APPLICATION NO.	FILING DATE	FIRST NAMED INVENTOR	ATTORNEY DOCKET NO.	CONFIRMATION NO.
10/814,478	03/31/2004	Mario Stigler	0275M-911/CO	7889
27572	7590	05/10/2005	EXAMINER	
HARNESS, DICKEY & PIERCE, P.L.C. P.O. BOX 828 BLOOMFIELD HILLS, MI 48303			WUJCIAK, ALFRED J	
			ART UNIT	PAPER NUMBER
			3632

Office Action Summary

This is the final Office Action for the serial number 10/814,478, RETAINING CLIP WITH OFFSET LATCHING FINGERS, filed on 3/31/04.

FIG. 4

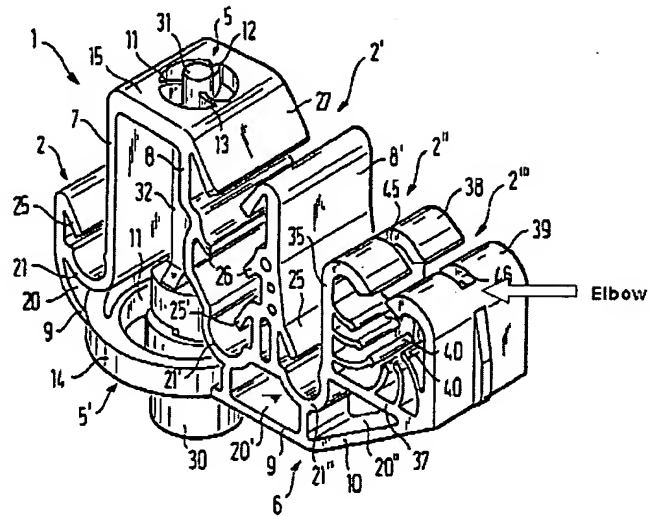
The applicant disagree that Kraus's invention shows elbow connecting the latching fingers. See the drawing below that the examiner indicated the location of elbow in Kraus

invention. The elbow in Kraus's invention is in between the two latching fingers and it maintains the latching fingers within the clip.
